Review of “Characterization of a self-sustained, water-based condensation particle counter for aircraft cruising pressure level operation” by Weber et al.

Citation: <https://doi.org/10.5194/egusphere-2022-1244-RC1>

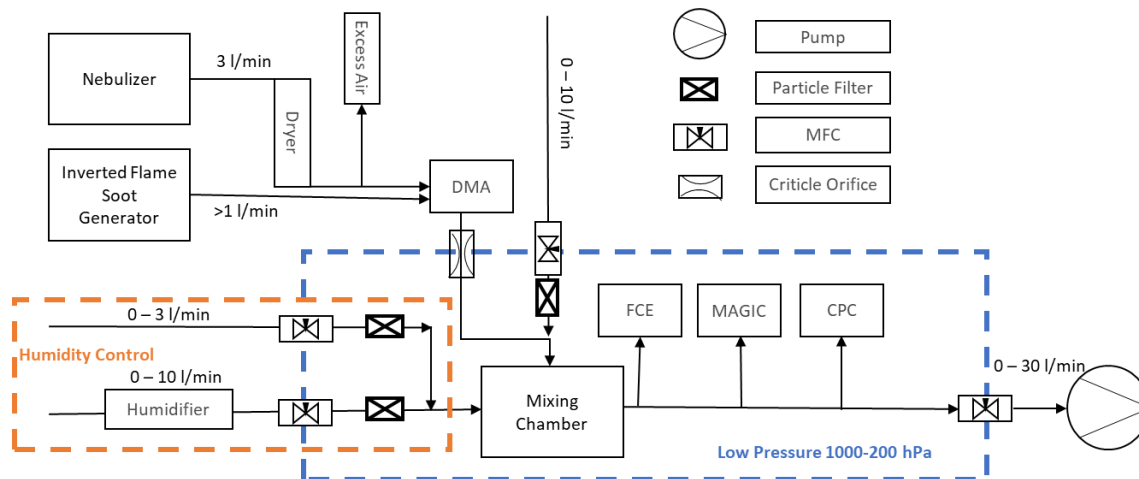
Figure 1: Many arrows are not straight, which is inadequate for a scheme. What is the difference between the line from the top labeled ‘flow control’ and the line from the left without label above the humidifier? If the butterfly symbolizes a MFC, why is the additional ‘flow control’ needed? G-CPC should be explained in the caption. Flow rate ranges (and pressure ranges) should be given for all flows, not only for one. Also the pump symbol should be in the legend for sake of completeness. A better match to ‘Humidifier’ would be ‘Dryer’ instead of ‘Dehydration’. The caption has an unmatched parenthesis.

You are right, this graph needed more love, so we added a few things:

Figure 1: Ideal signal from one particle passing through the optics detector

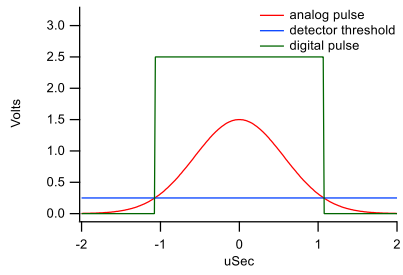
From 155-157 we learn that detector offset and threshold are different properties, but the

expressions are used before. Maybe a sketch of the instrument and its logic would help here following the explanation. Are offset and threshold applied to the same reference potential or do they apply to different part of the electronics?

Figure 1 shows an idealized signal from the optics electronics. The analog signal is compared to the “detector threshold” (normally 250mV) which produces a digital pulse that increments a counter in the microcontroller.

Figure 3: Detector threshold is increased to compensate for inability of the electronics to completely cancel out the baseline signal at lowest pressure.

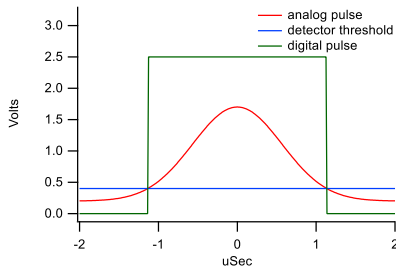
148-163: This seems to be one of the key achievements. But we learn here for the first time, that MAGIC is actually not specified for < 300 hPa, which might be one of the motivations of that study. Therefore, the problem should be mentioned in the introduction. Also, some more information on the optimization procedure would therefore be useful (plots). E.g., at which laser voltages and which sensor thresholds / offsets the system operated with what efficiency?

To operated the MAGIC 210-LP at pressures lower than then it was designed for, voltage offset and detector thresholds had to be determined experimentally below 300 hPa. At 250 hPa, we found that the required laser power was so high that the electronics was incapable of zeroing out the baseline voltage. To compensate the detector threshold was increased above the factory setting of 250mV (figure 3).

Note: due to specifics of the electronics a larger firmware setting for the detector lowers the baseline. Also the digital pulse are 0-5V; the height was reduced in the figures for clarity.
